1285 Washington Street,
Weymouth, MA 02189

Subject: 19 Highland Avenue
Randolph, MA 02368

The purpose of this letter is to respond to the Planning Director email comments dated August 31, 2022.

Drawing Number
A-3.01

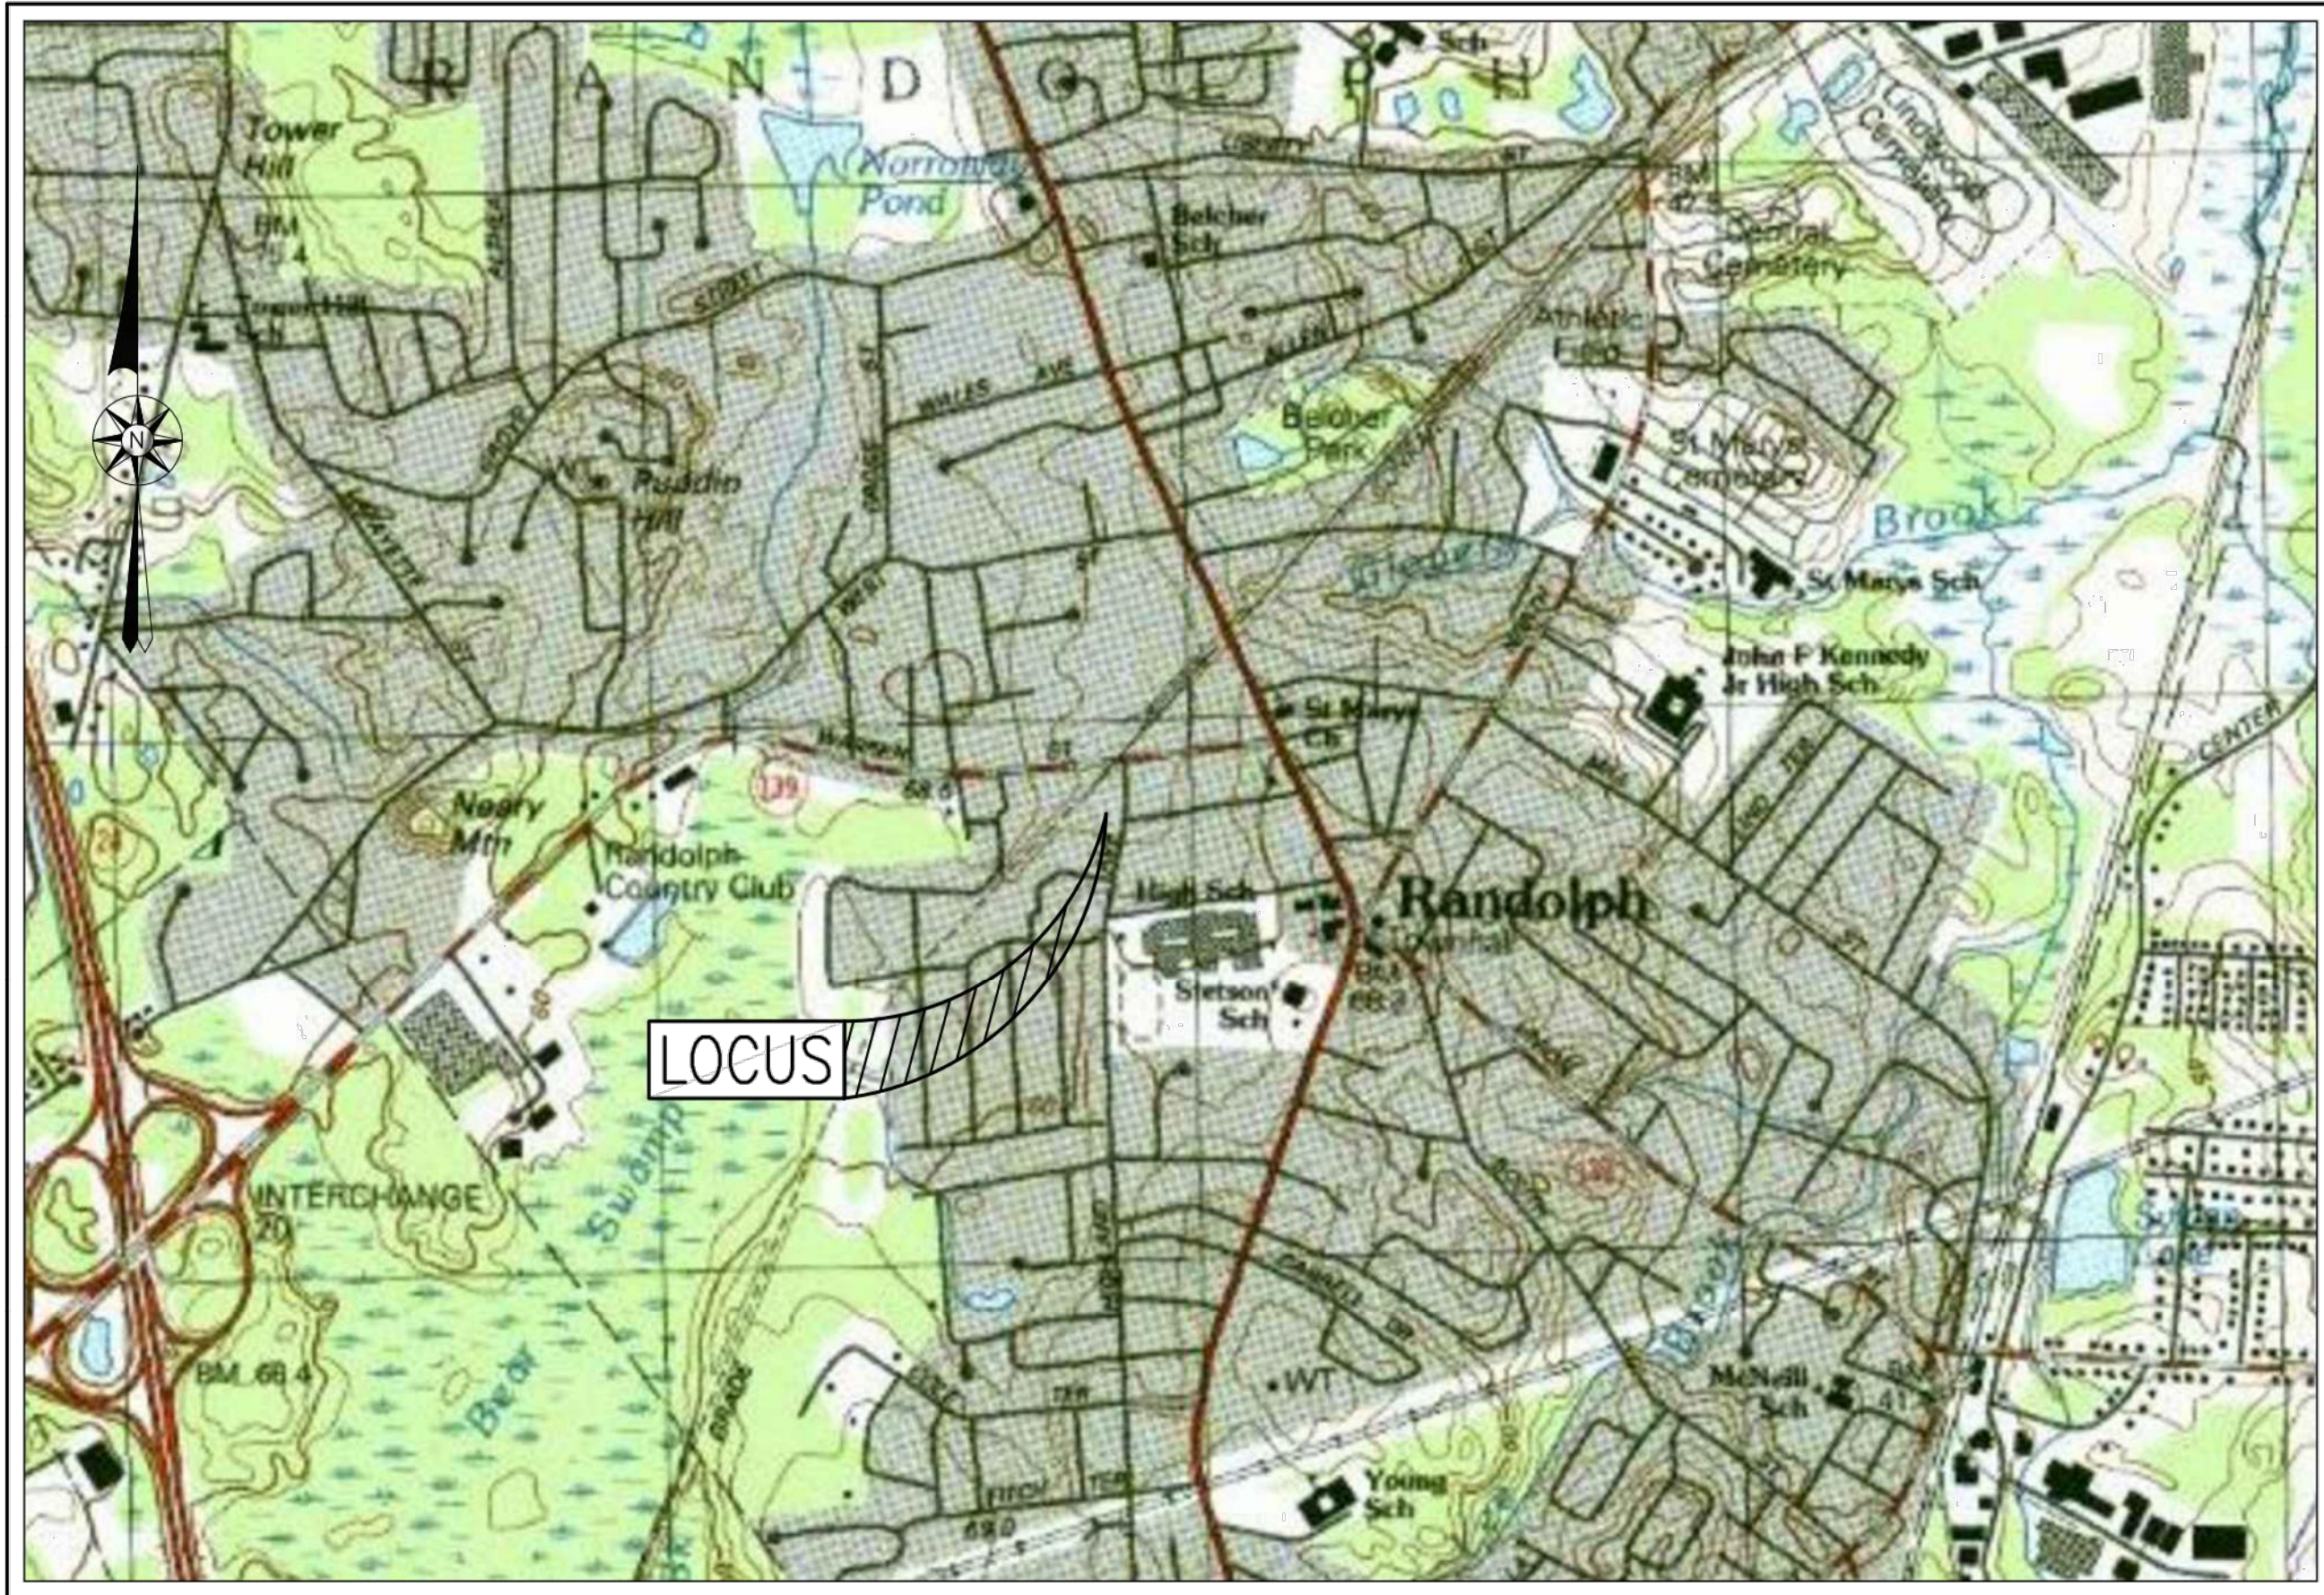
You provided a set of elevations (A-3.01 last revised 7-6-2021) that have prompted some questions and comments:

1) The roofline is bubbled with a notation that the change was approved in July 2021. I find no notes that the Planning Board provided a review in July 2021. Please advise who this was submitted to, the rationale for the change and who provided approval. Remember that the ENTIRE SITE PLAN for this site was subject to a SPECIAL PERMIT granted by the Planning Board. Only THAT REGULATORY BOARD has the authority to approve modified plans. There may be a rationale for this roofline change that is completely acceptable, however, it MUST BE REFERENCED IN THE PLANNING BOARD DECISION. We will want clarification that the height of the building has not increased beyond the maximum permitted threshold. Please provide information in a memo addressed to me or the Planning Board, not in an email or provided verbally. We will want something as part of the permanent record on file in the Planning Department.

2) On the elevations presented on the page, the directions seem to be incorrect. It appears that the top elevation is EAST, the second one is NORTH, the third one is WEST and the bottom one is SOUTH. That has been our interpretation. Please correct the plans or provide a clarification to correct our interpretation.

We are providing revised architectural plan A-3.01 showing the roofline changes and the memorandum from Form + Place Architects dated September 13, 2022, providing the roofline change explanation and building height clarification. We respectfully request the Board to review and accept these changes.

Please see the attached revised architectural plan A-3.01 Exterior Elevations showing the correct view directions.

SHEET 7 OF 11

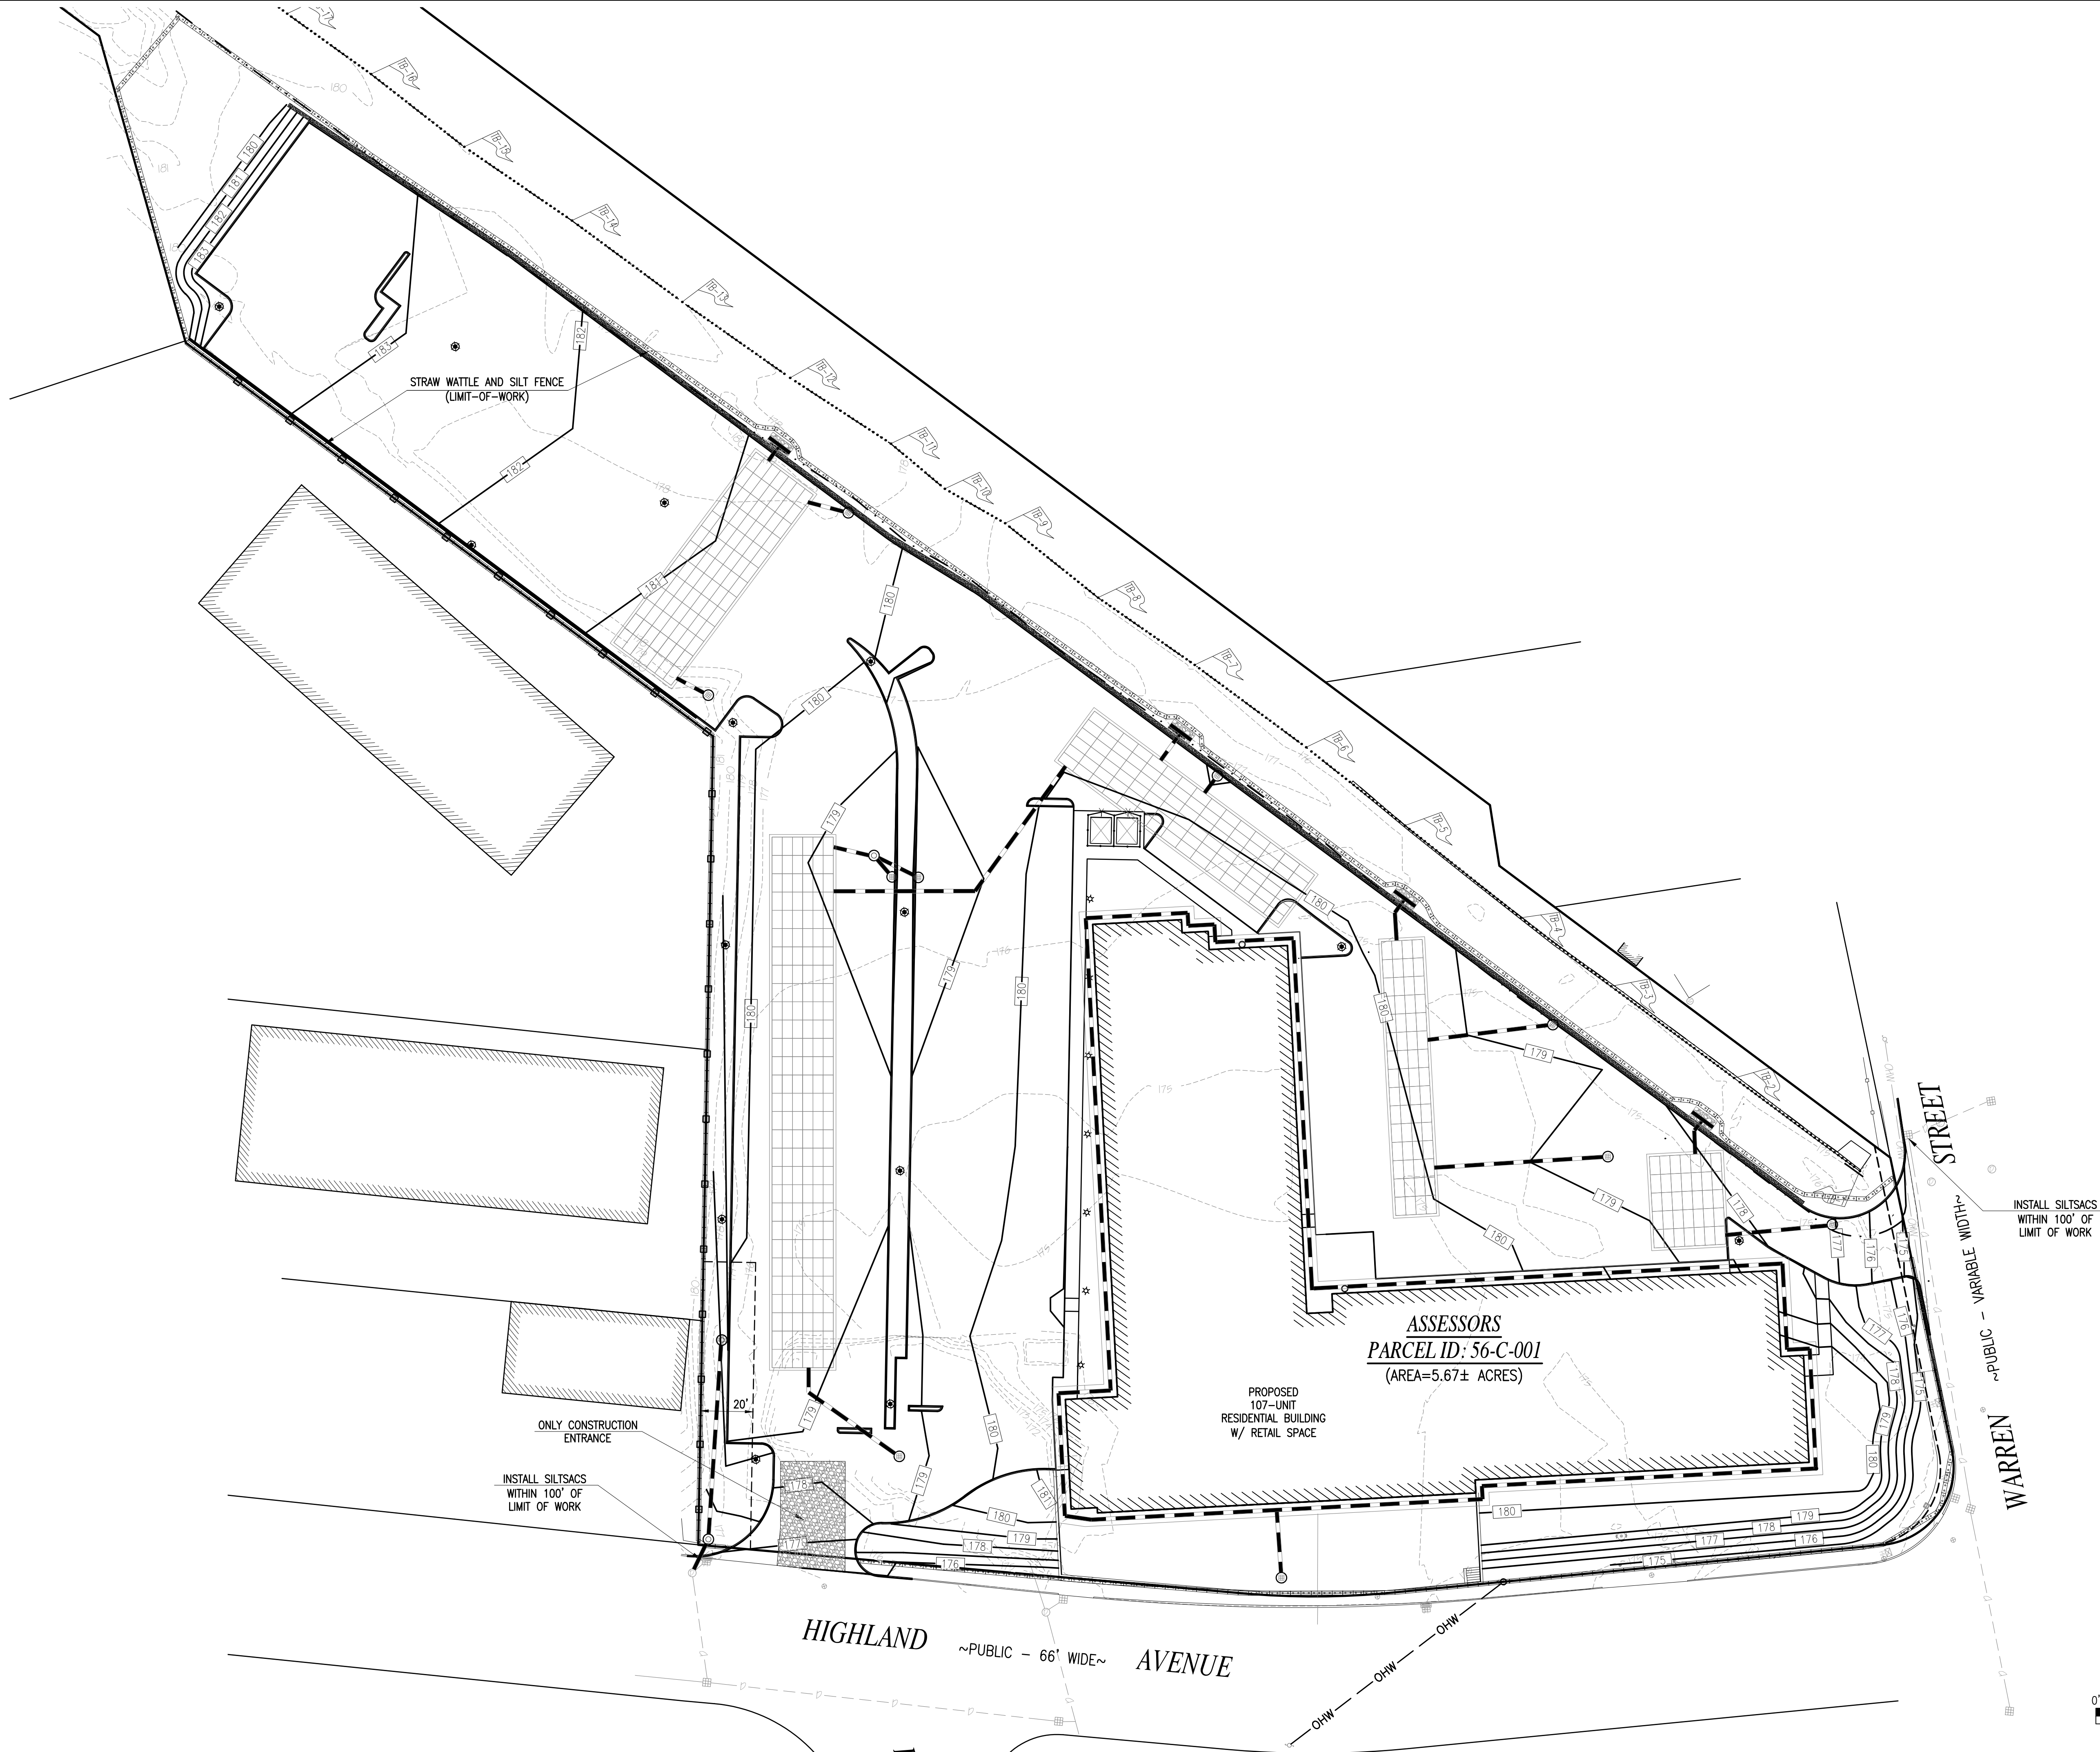
- After conducting a site visit on 8/16/22, we suggest that you keep trees in the planting island in the parking lot. Also, add tall fountain grasses or rosa rugosa as discussed. The strip should have robust landscaping.

- provide foundation planting around the stone drip line on the east side of the building. Use low plantings such as the proposed sweet gale, sweet fern, daylilies, etc.

- diversify the shrub plantings as outlined in our call 8/15. Some types to consider: potentilla fruticosa, ilex verticillata, philadelphus coronarius, rosa rugosa.

- add a few more trees along Highland

- consider using sweetbay magnolia as one of the tree species. Perhaps exchange for at least one of the red maple along Highland Ave.

- consider diversifying the proposed Nikko Blue hydrangea with oakleaf hydrangea (Alice or Gatsby pink)

-note that you have not submitted any plans for planting at the replication area located at the end of the parking lot (the southwestern end). Please provide a proposed plan of trees as discussed in prior meetings.

-callout any areas using mulch or stone. If stone, advise if it's river rock, process, gravel, etc.

Trees and enhanced landscaping is provided on the center planting island.

We have introduced a cluster of planting islands in front of the stone drip line on the east side of the building with mixed low growing species like Sweet Gale, Sweet Fern and Winter Berry.

We have introduced and diversified additional species of shrubs such as Sweet Mack Orange, Rugosa Rosa and Winter Berry.

Additional trees were added to the landscape strip along Highland Avenue with different variety of species.

We have added 2 Sweet Bay Magnolia to our plant list.

Gatsby Pink Oak Leaf Hydrangea was added to the mix with Nikko Blue Hydrangea.

We have added planting to the restoration area. The plants and ground cover selection is designed per the requirements by the Randolph Conservation Commission. Please refer to the attached correspondences from the Planning Board and Conservation Commission.

The mulch, grass and stone drip areas are now identified on the plan. The stone drip area will be lined with washed landscape stone.
